SERVICE INFORMATION LETTER NO. 0152

Revision 1

1. SUBJECT: Idler Pulley Alignment and Snubber Roller Adjustment
2. MODELS: F-28A, 280, F-28C, F-28C-2, F-28C-2R, and 280C
3. EFFECTIVITY: All Serial Numbers
4. BACKGROUND:

Figure 1. Belt Tension Assembly Pylon Mount Inspection Areas

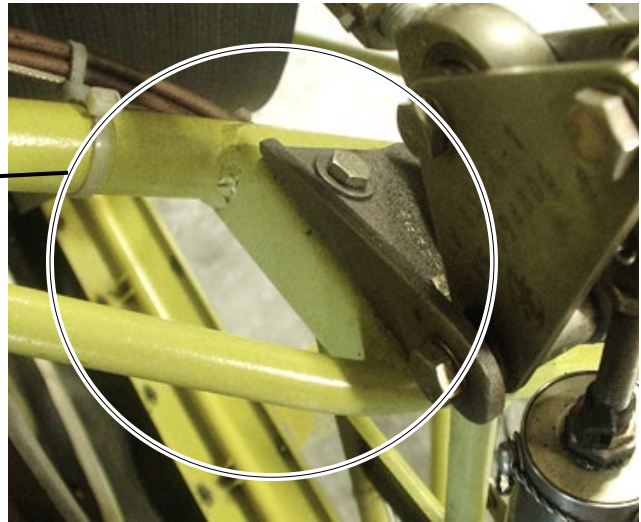
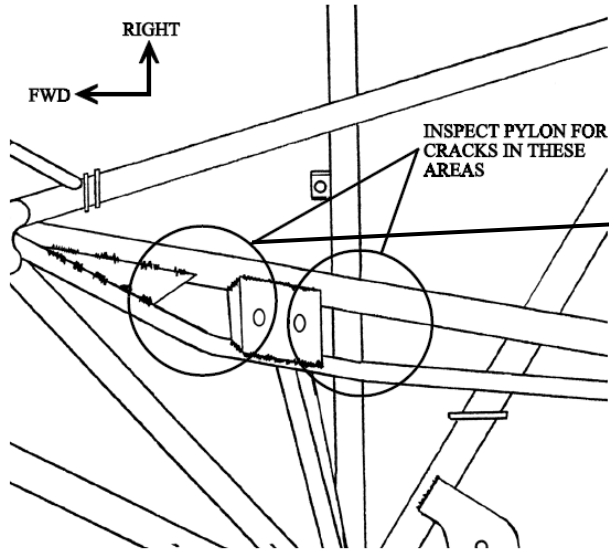
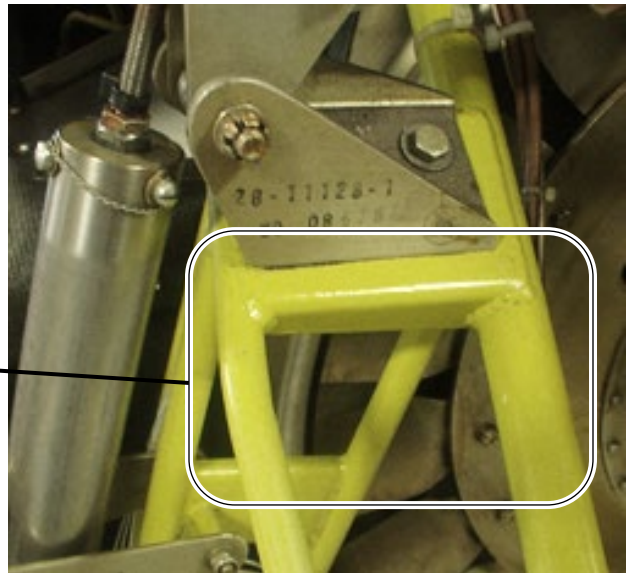
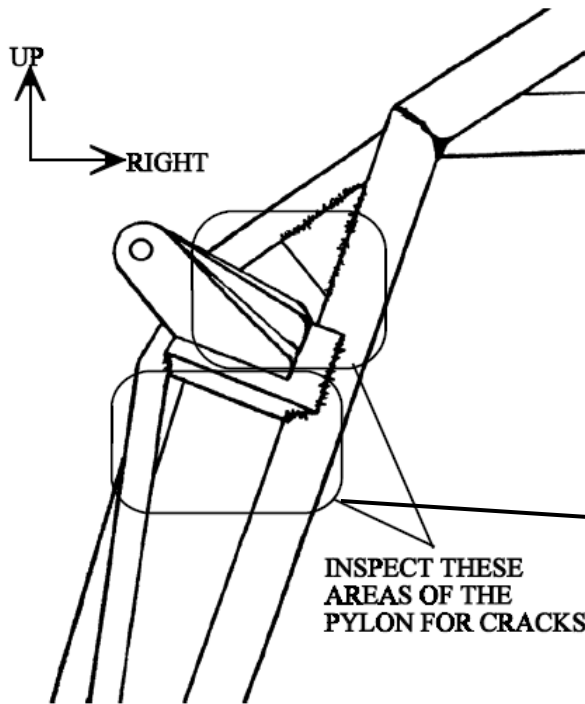
This Service Information Letter (SIL) was initially published when Enstrom had received a report from an operator of a broken pylon. The failure occurred in the area adjacent to the mounting bracket for the belt tension assembly bracket (Refer to Figure 1). As previously reported in the initial SIL issue, a review of Enstrom's records indicated that other than the reported failure there had been three failures in this area in the ten years prior to 2001. No related failures have been reported since that time. Enstrom believes the failures are not a chronic problem and were probably a result of either a rough belt or improperly adjusted belt tension and idler pulley adjustment.

5. COMPLIANCE:
 - A. Unless complied with at the time the SIL was originally issued, Enstrom recommends visually inspecting the pylon area adjacent to the belt tensioning assembly mounting bracket for cracks and other damage within the next 10 flight hours (refer to Figure 1). If no damage is found, return the aircraft to service. If damage is found, repair in accordance with AC 43.13-1B or contact Enstrom Customer Service for specific repair instructions.
 - B. Inspect the belt tensioning assembly in accordance with the inspection checklist found in Table 1 during the 50 hour periodic inspections.

Figure 2. Idler Pulley Tracking (Viewed from Right)

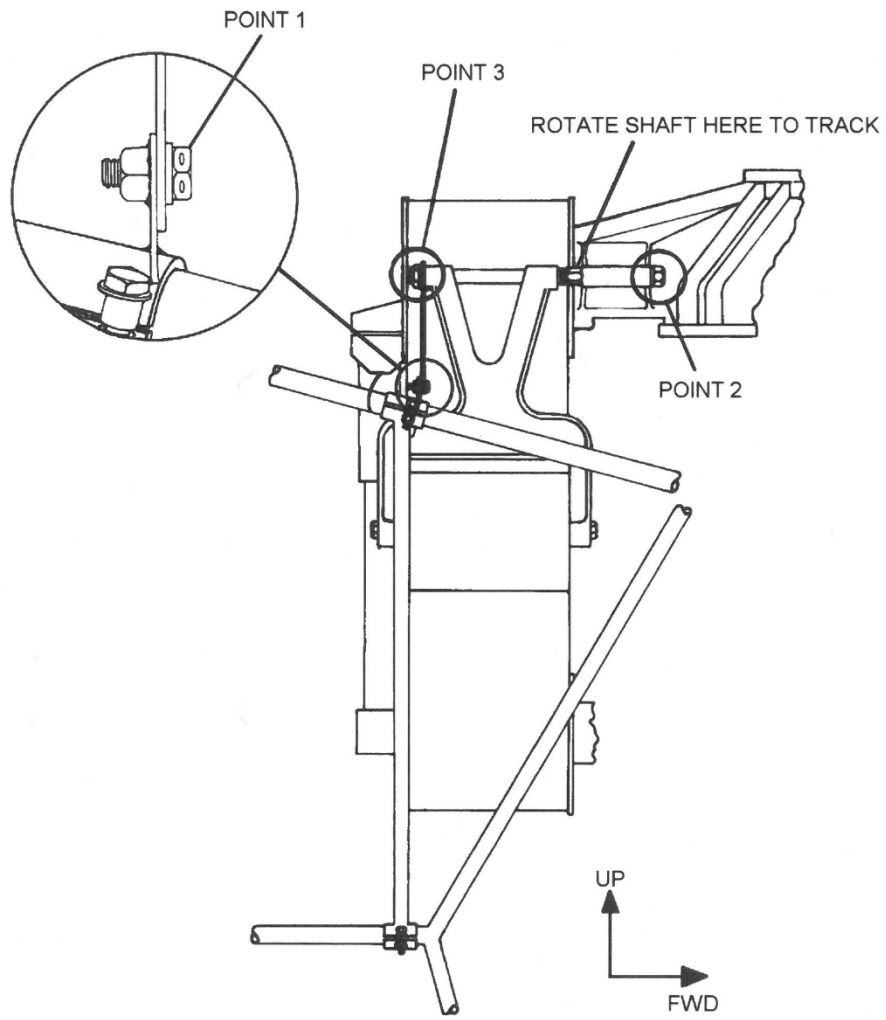
- C. Check/Adjust the idler pulley track using the following procedure (refer to Figure 2).
1. Remove the upper cowling if not already accomplished.
 2. Decrease the torque on the bolt and nuts at Points 1 through 3. The bolts and nuts at points 2 and 3 should be snug enough that they require force to turn but not be "loose." Point 1 must be loose enough to allow the idler stabilizer strut to slide as the idler support shaft is turned.
 3. Rotate the idler support shaft using a wrench so that Point 3 is at the highest position. Then rotate the shaft approximately 75° towards the right side of the aircraft (clockwise looking forward).

6. When the pulley is centered, tighten the bolt at the pylon strap (point 1).
8. Holding the idler support shaft with the wrench, tighten the forward idler shaft nut (point 2) to 600-780 in-lb/68.2-88.6 Nm and then tighten the aft nut (point 3) to 290-410 in-lb/33.0-46.6 Nm.

12. After engine shutdown:
 - a. Inspect the assembly for security.
 - b. Torque bolt at the pylon strap (point 1) (50-70 in-lb/5.7-8.0 Nm).
13. Reinstall cowling.
